**PROPOSITION 39
ENERGY EFFICIENCY UPGRADES
EEP3**

**PHASE 2 & PHASE 3
ADDENDUM 05**

To: All bidders
From: John Fisher, AIA, Principal
Project: SBCUSD Proposition 39 Energy Efficiency Upgrades EEP3
Phase 2 & Phase 3- Energy Upgrades
Date: February 26, 2019

3. Bid Package # 1 (Phase 2) – HVAC Cajon High School - Revisions
Sheet G0-02, M1-02 & M1-11, Delta 1 Revision per DSA comments.

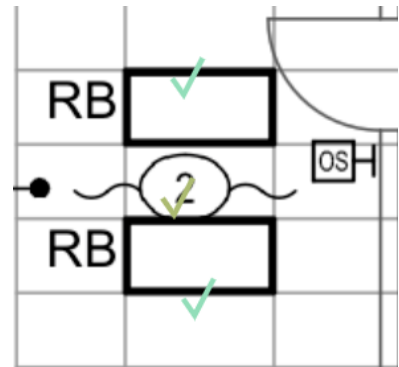
15. Per the photo (at the right) of an office in Pacific High School, are we to just count this as a single pole since it does not say ab? Or do we need to make this into a 2 pole switching office?

The photo is small room; this requires Single Pole occ sensor. Please field verify what is existing.

Project No: 1715
Phase: DSA APPROVAL SET
Date: JANUARY 10, 2019
Scale: AS NOTED
Drawing No:
G0-02

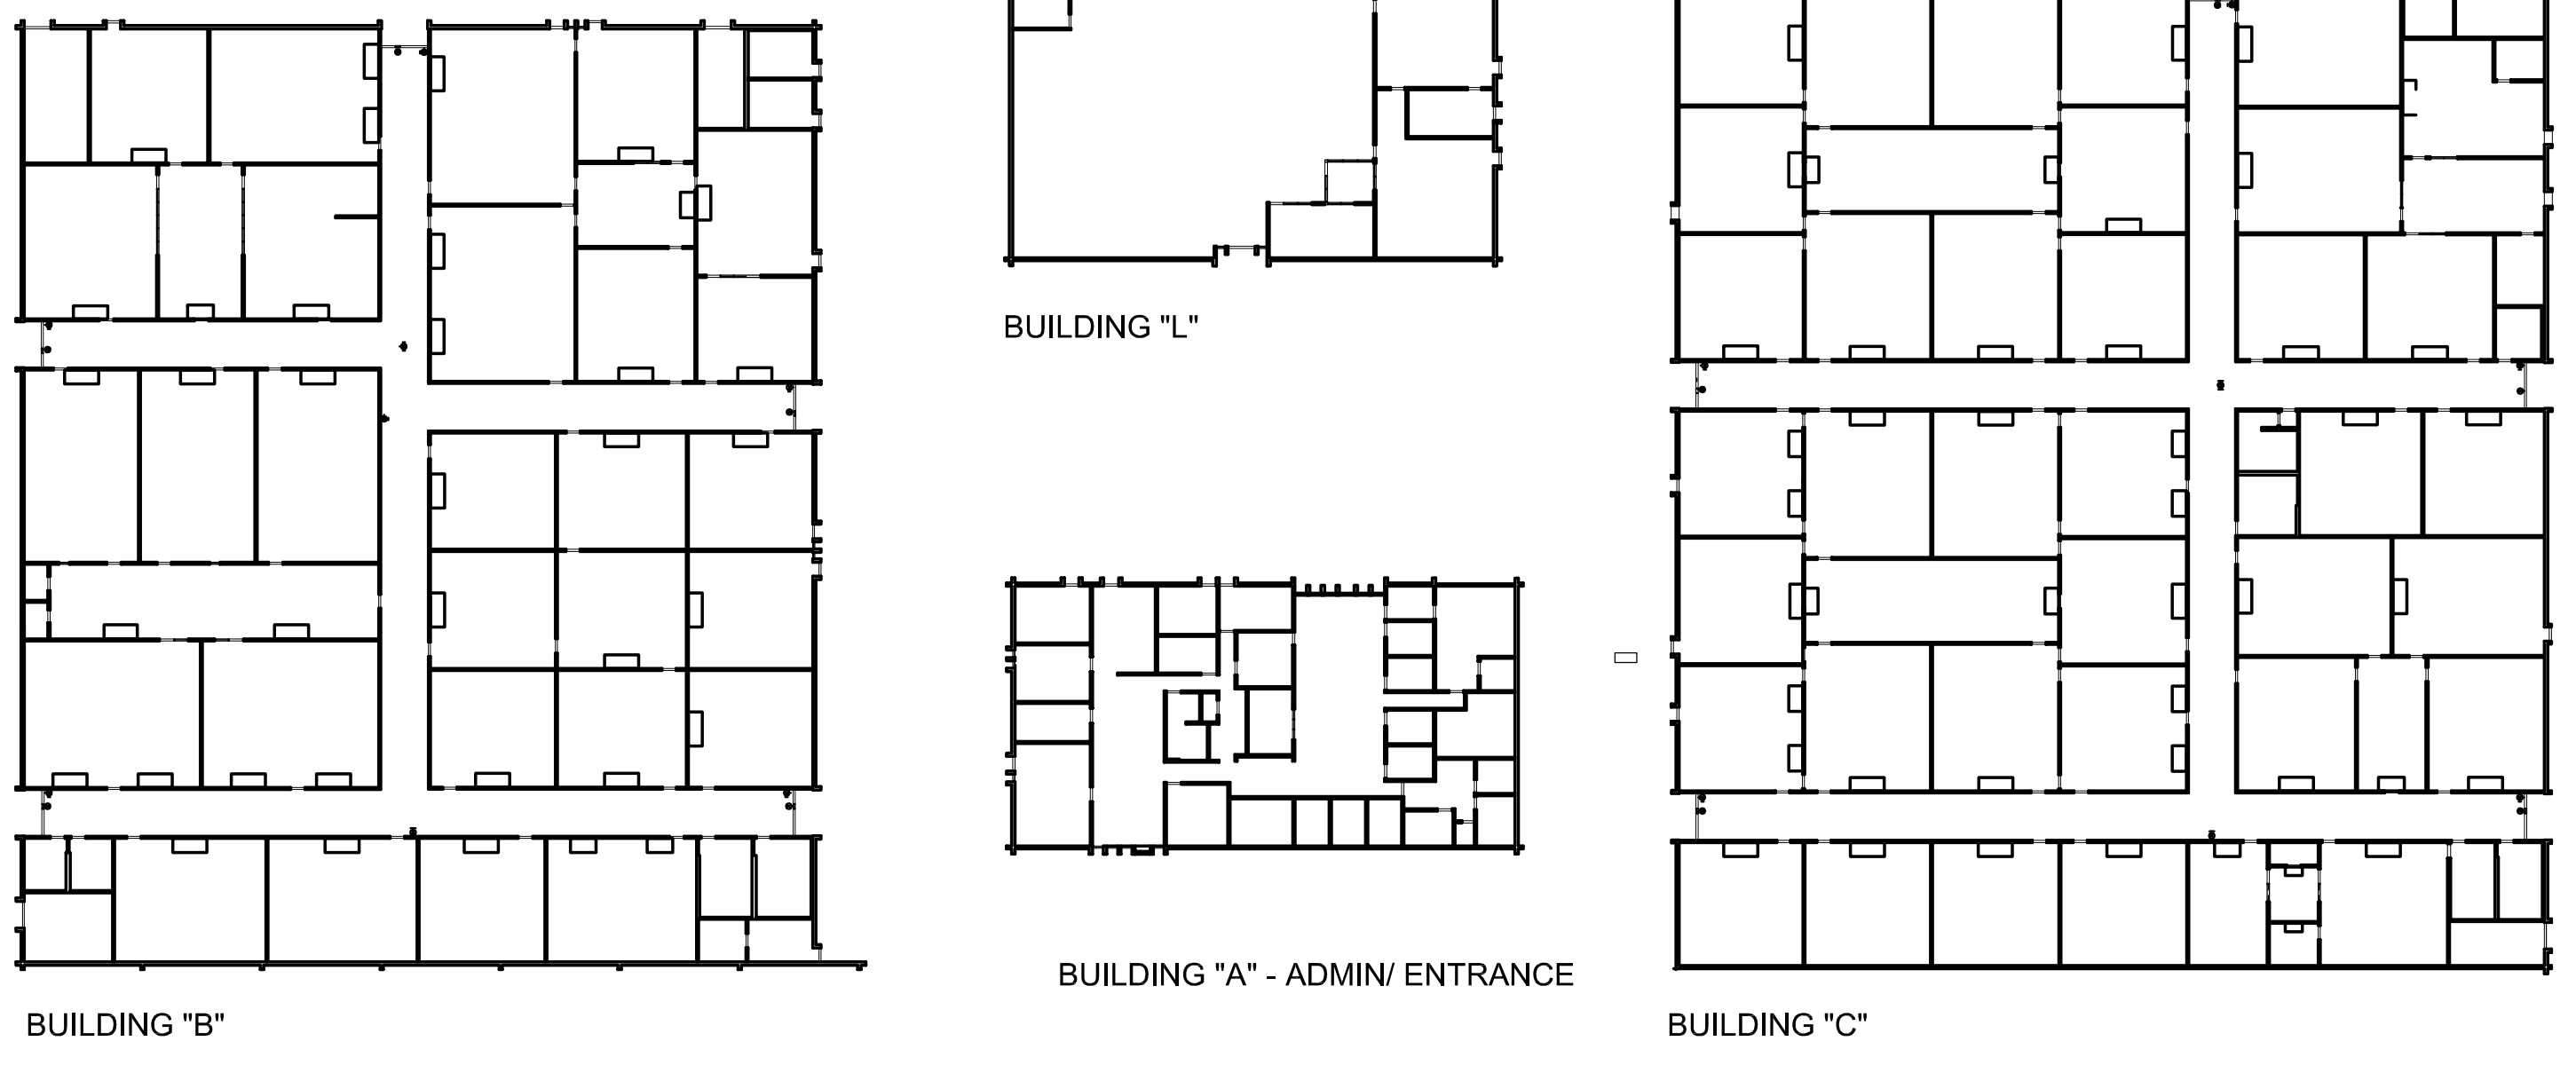
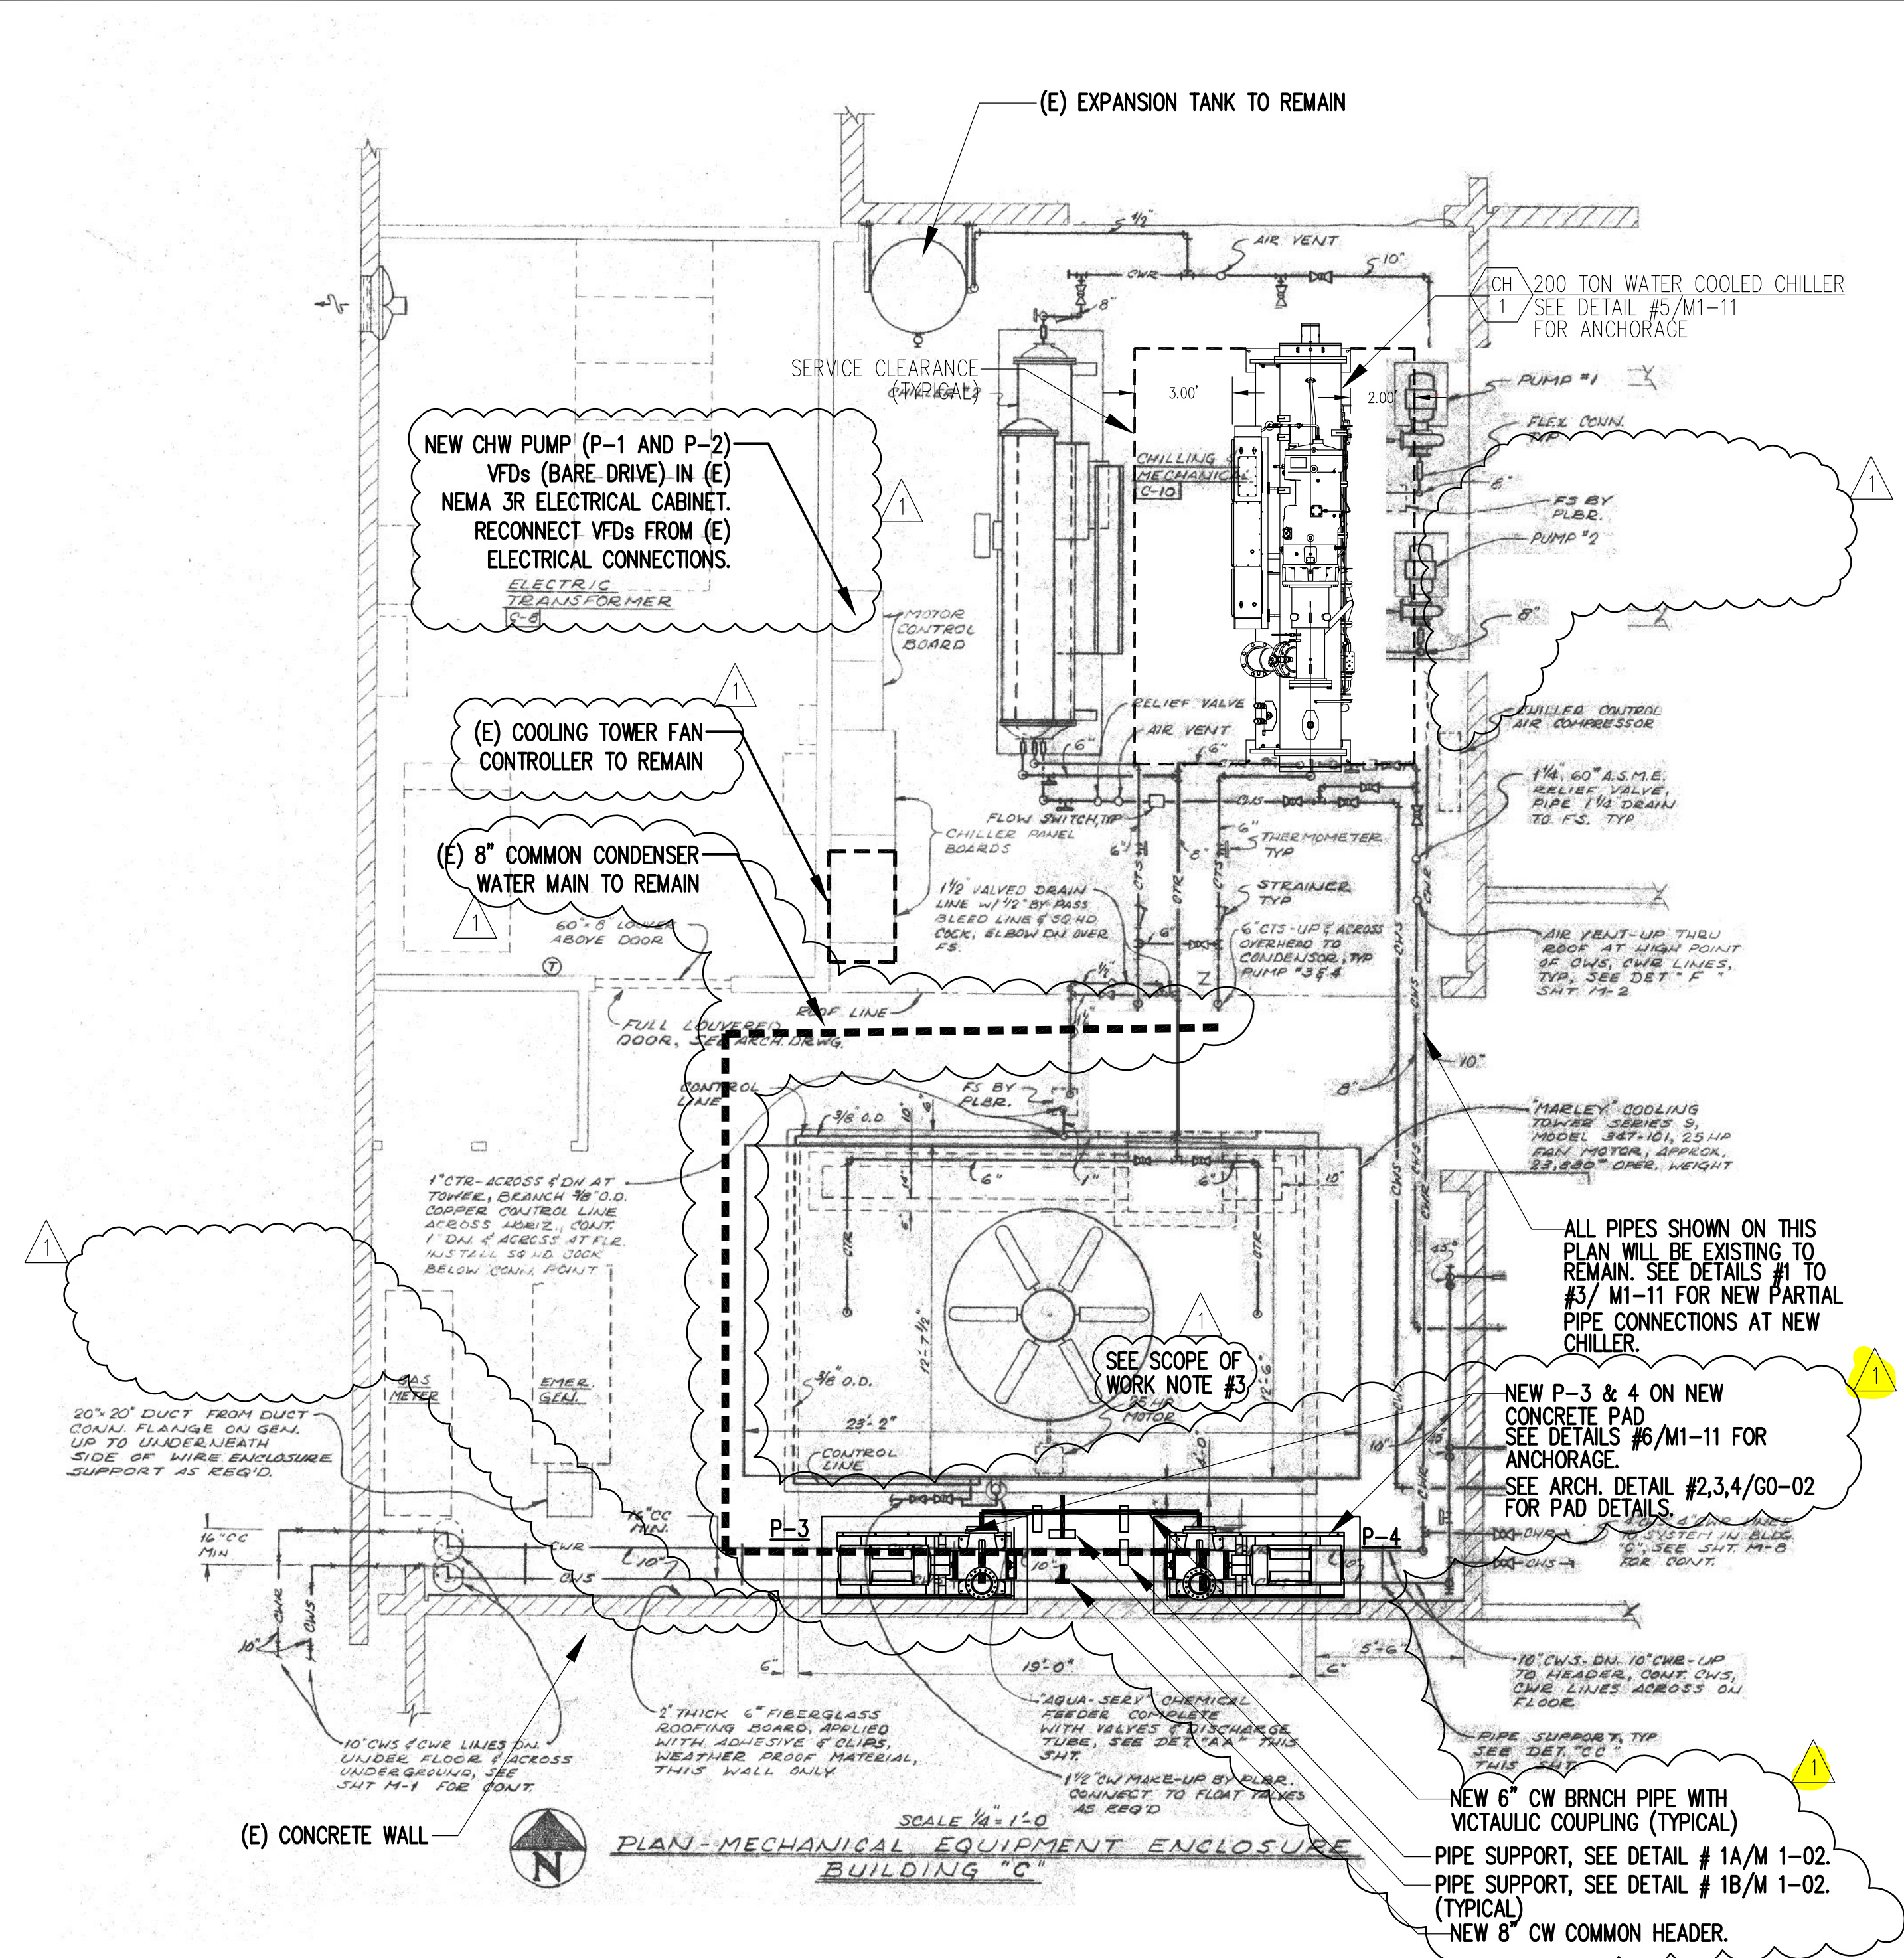
REMOVE EXISTING CHAIN LINK FENCE WHEN DEMO OF CH-1 OCCURS AND INSTALL NEW CHAIN LINK FENCE AFTER NEW CH-1 IS COMPLETE- SEE SPEC.

NEW CHILLER (CH-1) TO FIT ON NEW CONC. PAD, SEE DETAIL#2

REMOVE 2 EXISTING CONDENSER WATER PUMPS, DEMO 2 EXISTING CONC. PADS, REPLACE WITH NEW PUMPS P3 & P4, ON (N) CONC. PADS --DETAIL #2
